MEMORANDUM

TO: Richard Harris, AICP, Director of Planning, South Hadley, MA
FROM: M. James Riordan, AICP, LEED AP, Senior Project Manager
DATE: March 4, 2020
SUBJECT: North Pole Estates Peer Review

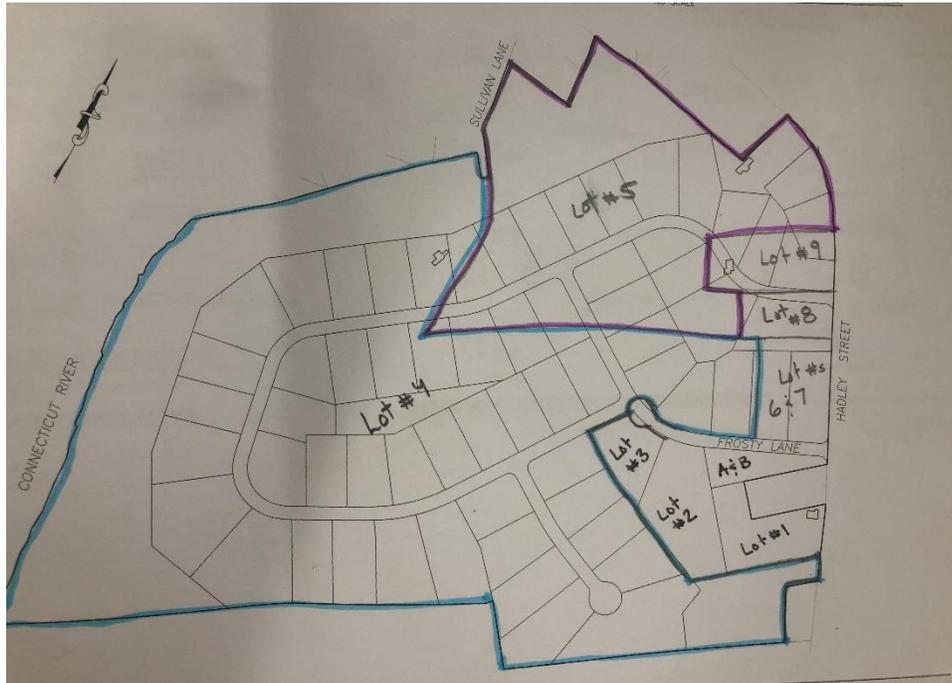
Generally, we find that the Definitive Plans were prepared in accordance with Chapter 360 of the Town's Bylaws; however, we did find inconsistency between the layout dimensions of the Preliminary Plan and the Definitive Plan. The Definitive Plans depict lots 1 through 9, with lots 4 and 5 containing the bulk of the land that would eventually be the remainder of the proposed 67 lots. Many of the lot lines shown for initial lots 1-9 do not coincide with any lot lines for future phases. See the hand-drawn graphic below:

The applicant does not provide a comparison of the lot layout that was proposed for the approved preliminary plan and the lot layout that was proposed for the proposed definitive plan, but there appear to be discrepancies. The drawing above shows the approximate location of lots lines for lots 4, 5, 8 and 9. Those lines do not appear to coincide with future development lots as depicted. This calls into question the validity of lots 4, 5, 8 and 9 as they do not seem to coincide with lot lines for future development. To address this issue, we recommend that the Town request a phasing plan from the applicant that clarifies why lots 4, 5, 8 and 9 are being created as depicted. We anticipate that future phases will require either redrawing or amendment of the lot lines. This also raises a question related to the ultimate ownership of areas in lots 4 and 5 that are not part of the depicted full-build layout. We recommend that the Town ask for a clarification of this issue.
